895 Riverbank Drive

Public Meeting 21 November 2023

Comments on the Plan of Subdivision

Removal of Large Central Park North Cambridge Secondary Plan

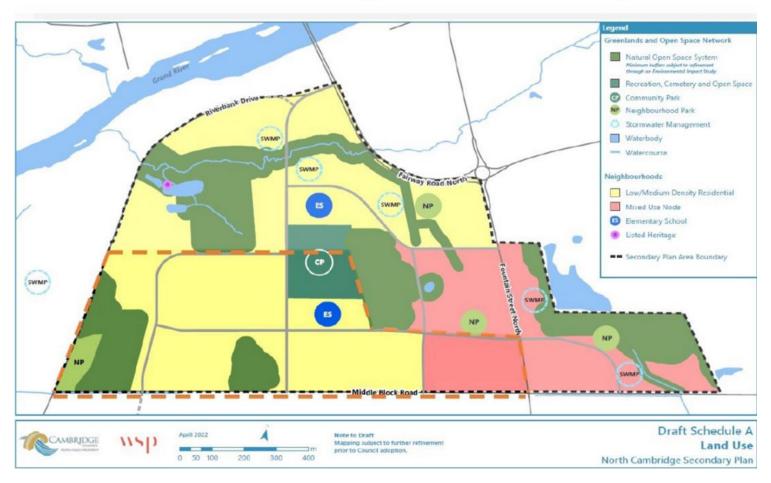
Removal of Large Central Park

Madison Riverbank Holdings Inc. Urban Design Brief

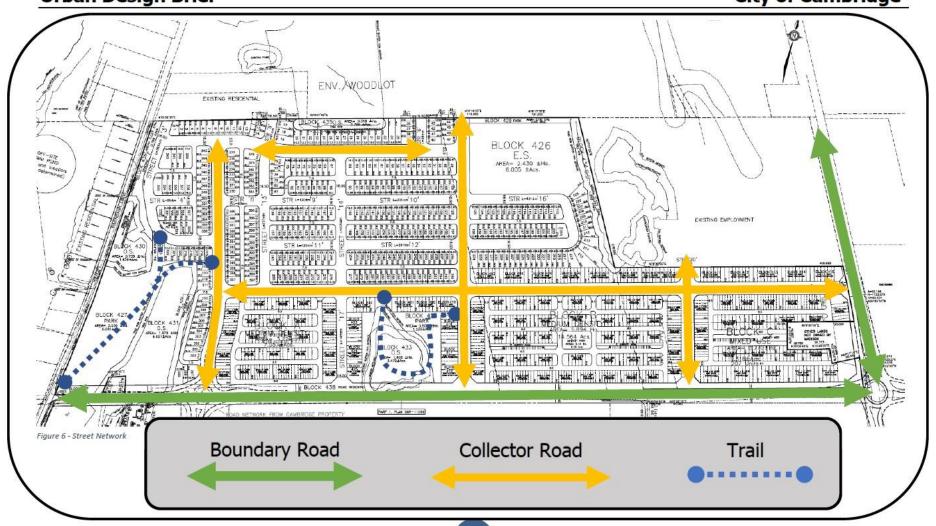
Few Parks/Trails

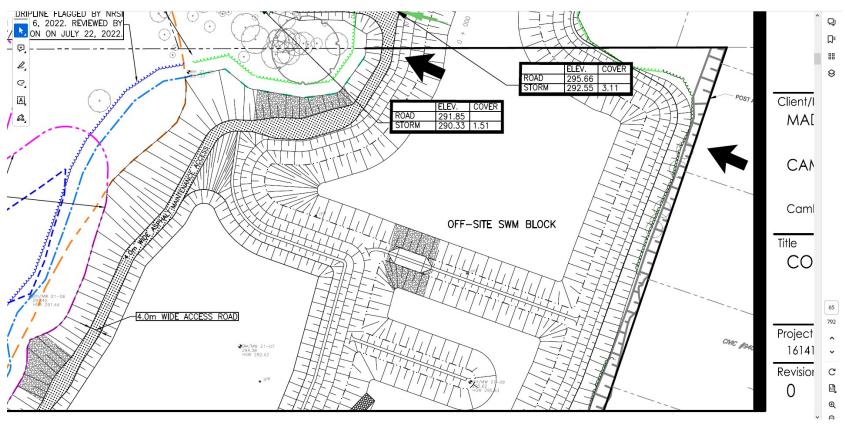
Impact on Riverbank Dr - Wells

The subject site is located in a Well-Head Protection Area (WHPA) – D and approximately 0.6 km southeast of WHPA – A. (Source: Records Review)

One (1) well at the subject site and twenty-eight (28) more wells are documented within the Phase One Study Area. (Source: Records Review)
